NCUTCD Proposal for Changes to the Manual on Uniform Traffic Control Devices

TECHNICAL COMMITTEE: Signals Technical Committee
ITEM NUMBER: 19B-SIG-03
TOPIC: Pedestrian Pushbutton Locations
ORIGIN OF REQUEST: Signals Technical Committee
AFFECTED SECTIONS OF MUTCD: 4I.06 Pedestrian Detectors

Figure 4I-X. Pushbutton Location Area

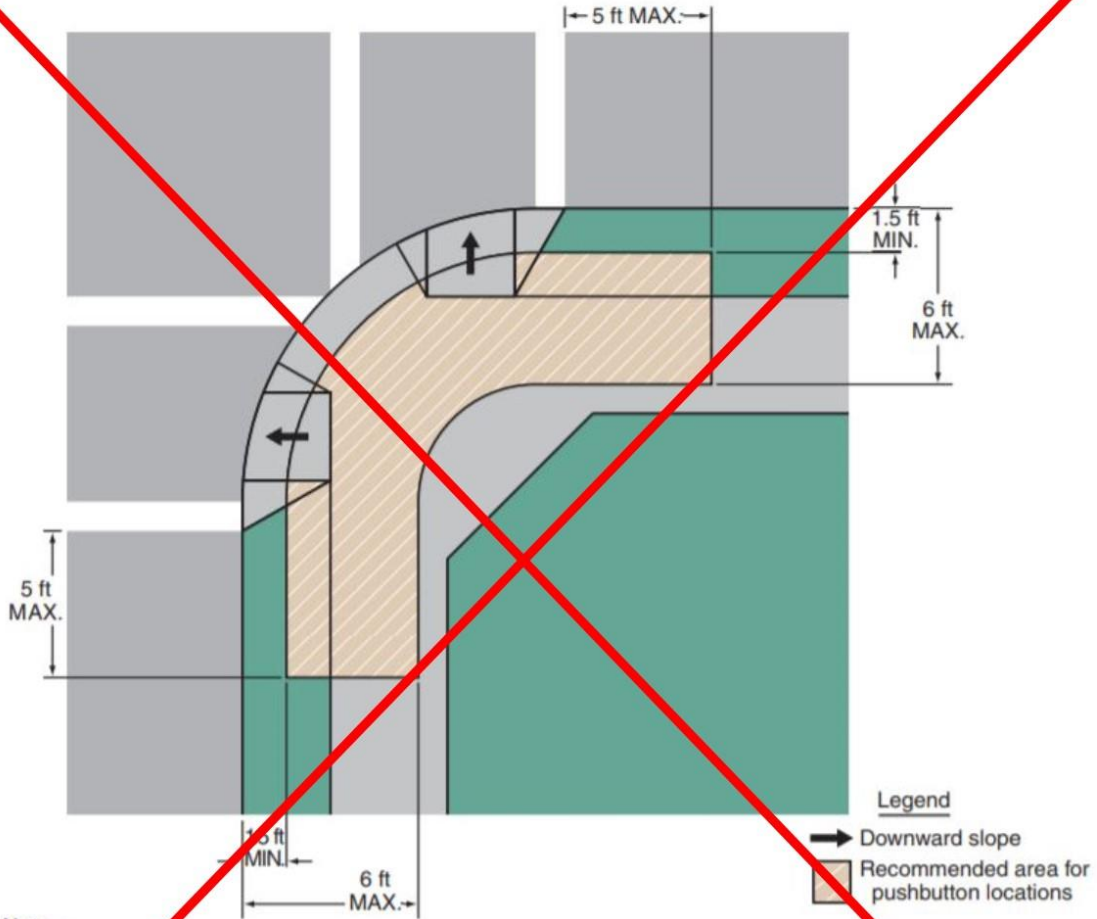
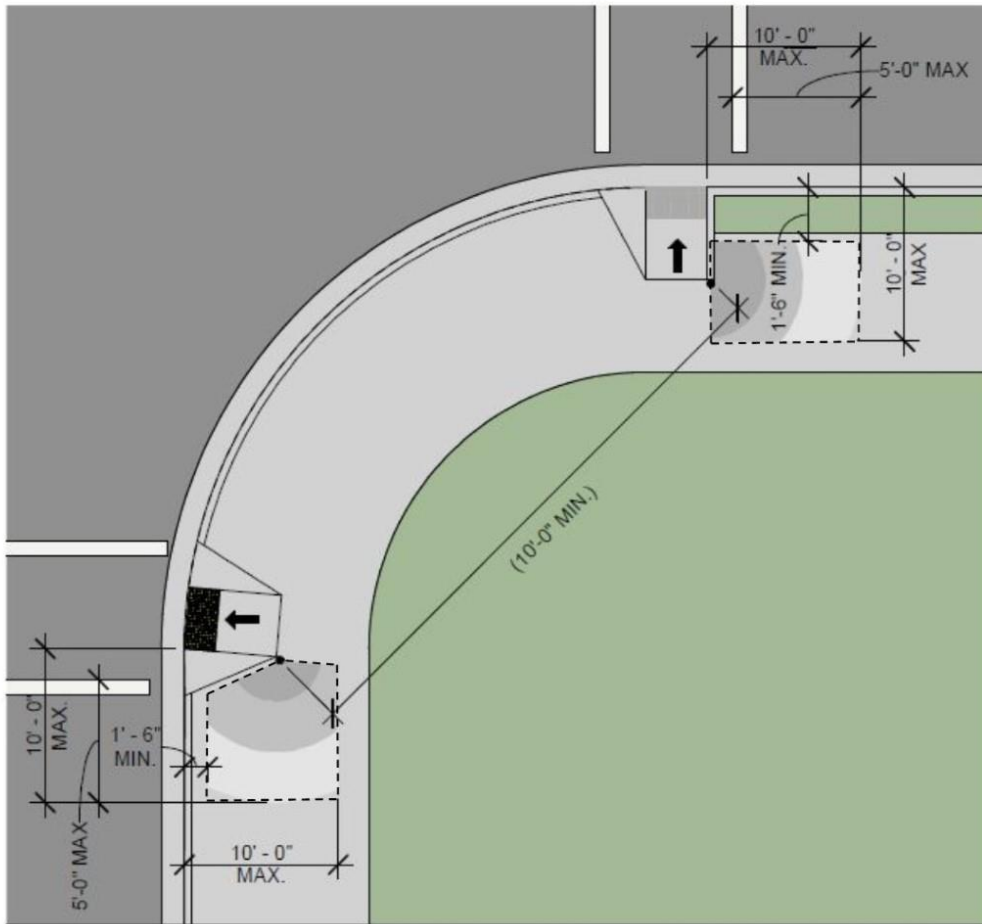
Provisions for pedestrian detectors were reviewed with respect to updating guidelines to better reflect accessibility needs. There are ideal locations for the placement of pedestrian detectors to serve accessibility needs. However, field conditions do not always allow for the optimal placement. Accordingly, revised language is proposed which would clarify optimal placement of pedestrian detectors while allowing for defined flexibility and latitude, where necessary, to accommodate unique conditions for a given location. These revisions are shown in a revised Figure 4I-X, formerly Figure 4E-3."

78 04 If pedestrian pushbuttons are used, they should be capable of easy activation and
79 conveniently located near each end of the crosswalks. Except as provided in Paragraphs 5 and
80 6, pedestrian pushbuttons should be located to meet all of the following criteria (see ~~Figure 4E-3~~
81 Figure 4I-X):

- 86 ~~C. Between the edge of the crosswalk line (extended) farthest from the center of the~~
87 ~~intersection and the side of a curb ramp (if present), but not greater than 5 feet from said~~
88 ~~crosswalk line;~~ [Removed because it is often better for blind pedestrians to stand at the
89 edge of the access ramp farthest from the intersection nearer the tangent section of the
90 curb so as to provide clearer delineation of the edge of the roadway. The removed
91 language does not allow this.]

- 92 C. On the side of the curb ramp which is farthest from the center of the intersection; [Added
93 language attempts to provide more uniformity as well as greater separation between
94 buttons on a corner]

- 95 D. Not greater than 10 feet from the edge of the curb ramp which is farthest from the center
96 of the intersection; [Added language clarifies that the button should not be greater than
97 10 feet from the ramp]

- 98 E. Not farther than 5 feet from the outside edge of the marked crosswalk farthest from the
99 center of the intersection, and not farther from the curb ramp than the stop line, if
100 present; [Added language clarifies how close to the ramp the buttons should be placed]

[Figure 4E-3 to be replaced with Figure 4I-X]

1. The pushbutton should not be farther than 5 feet from the outside edge of a marked crosswalk farthest from the center of the intersection, and not be farther from the curb ramp than the stop line, if present (Stop line not shown in figure)
2. Any maximum (MAX) or minimum (MIN) dimensions shown are based on Guidance Statements
3. Two pedestrian pushbuttons on a corner should be separated by at least 10 feet. The 10 foot dimension shown in this figure is in reference to the near points of the recommended area.
4. Figure 4E-4 shows typical pushbutton locations.
